Docket Number:	17-BSTD-02
Project Title:	2019 Title 24, Part 6, Building Energy Efficiency Standards Rulemaking
TN #:	222480
Document Title:	Comment on New Refrigerant Economizer Exception
Description:	Comment on the proposed 2019 Standards by Jeff Stein, Taylor Engineering. Sent electronically by email and docketed by staff.
Filer:	Adrian Ownby
Organization:	California Energy Commission
Submitter Role:	Commission Staff
Submission Date:	2/8/2018 10:53:46 AM
Docketed Date:	2/8/2018

To: CEC
From: Jeff Stein
Subject: Comment on New Refrigerant Economizer Exception
Date: February 7, 2018

Please do not add this proposed new exception to the computer room economizer requirement:

Figure 1. Fraction of Year for All Economizer, No Economizer and Integrated Economizer Operation For CRAC/CRAH units with SAT = 65F and RAT = 85

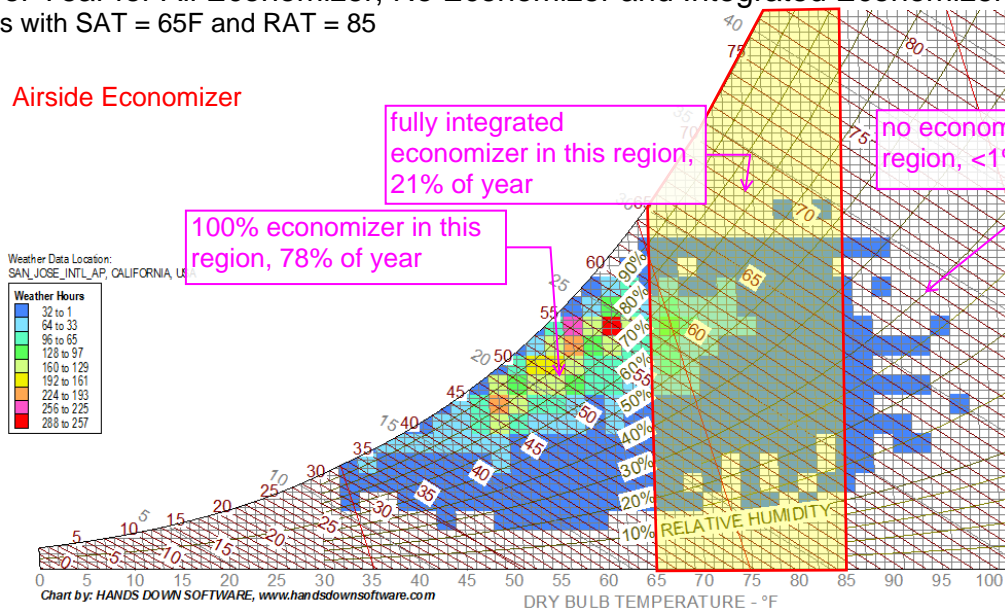
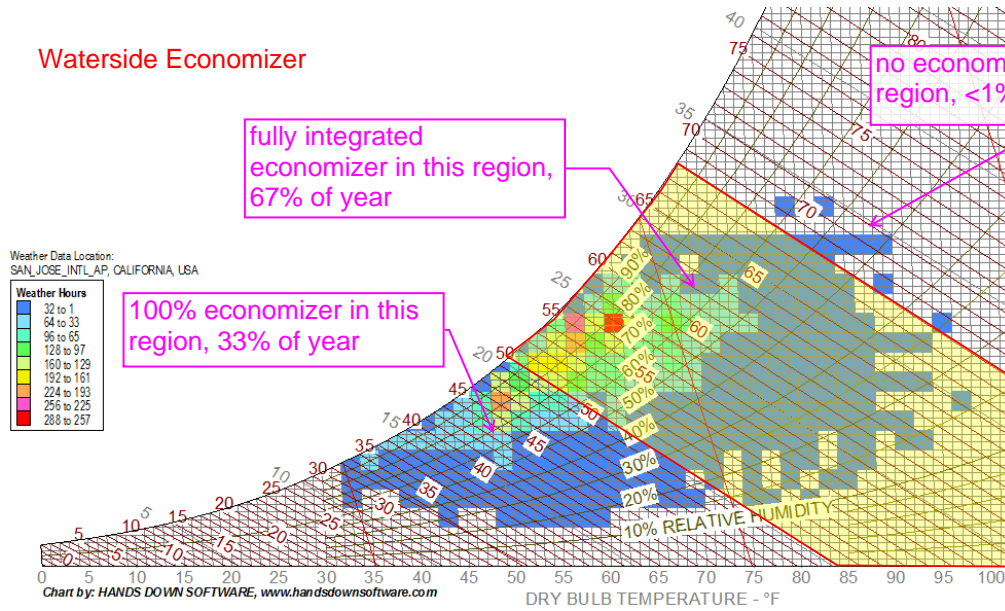
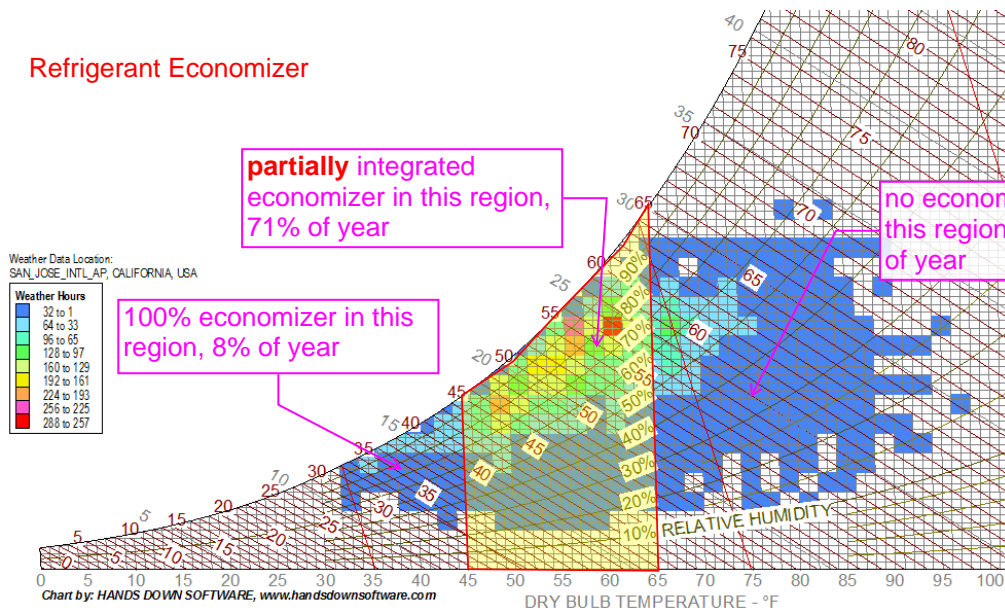
1. A refrigerant economizer is not nearly as efficient as an airside economizer or a waterside economizer.
 - a. Figure 1 shows the hours per year in San Jose when each type of economizer is typically in 100% free cooling, no free cooling, and integrated free cooling. For example, a refrigerant economizer can meet 100% of the load only about 8% of the year, compared to 33% for a water economizer and 78% for an air economizer. Clearly the refrigerant economizer is the worst in terms of potential free cooling.

Figure 2. Fully Integrated Economizer vs Partially Integrated Refrigerant Economizer
 For CRAC/CRAH units with SAT = 65F and RAT = 85

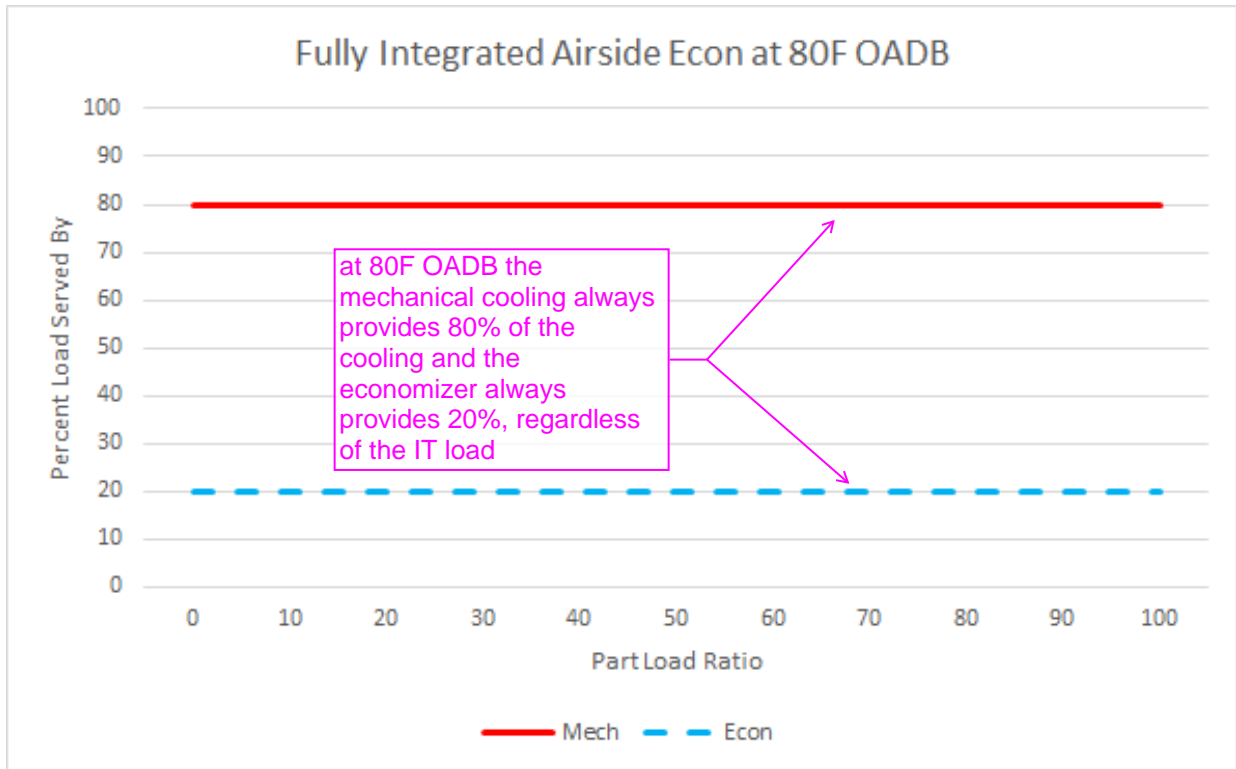
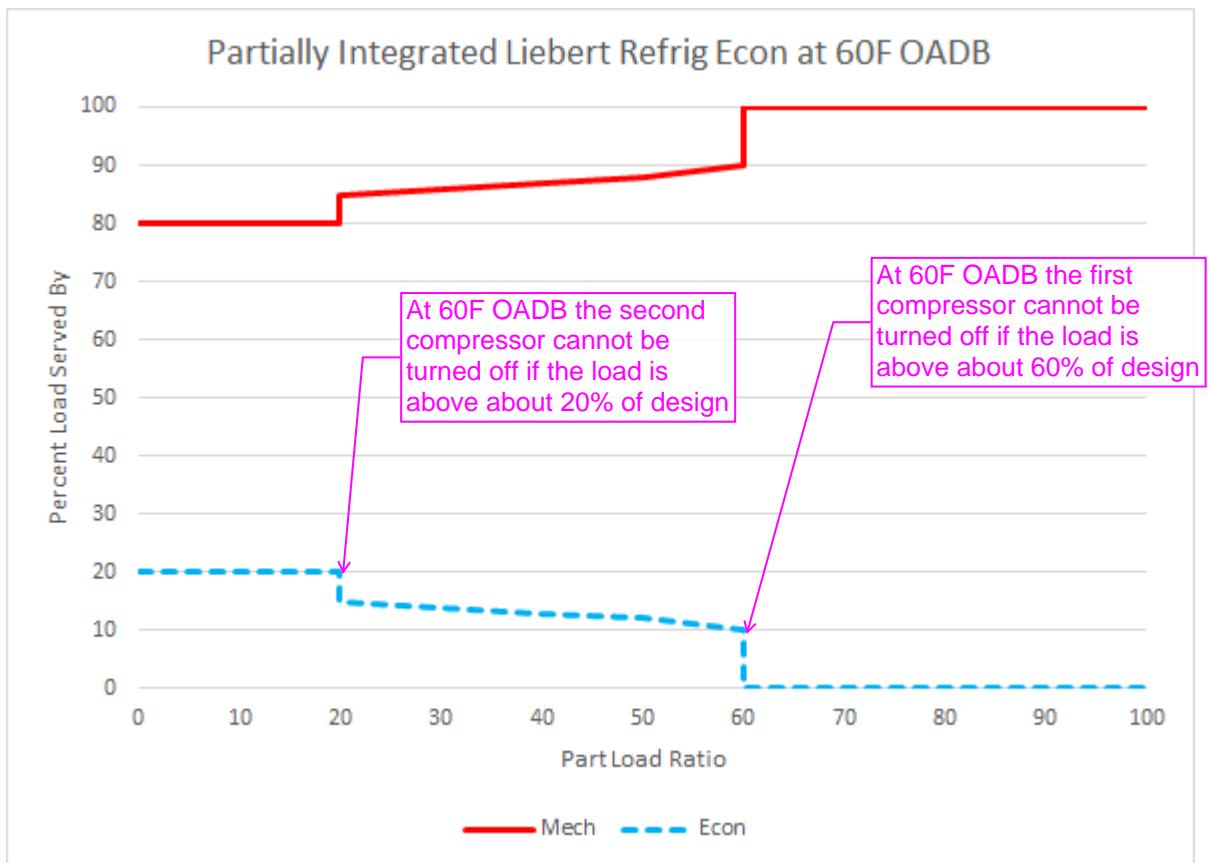
- c. In a best case scenario, the controls would work roughly as shown in Figure 2. This shows that even if the ambient temperature is low enough to enable the economizer, the economizer cannot be enabled if the load is high.

For an airside economizer the economizer can provide about 20% of the load at about 80F OA drybulb.

At 60F OA drybulb the refrig econ can provide somewhere between 0% and 20% of the load.
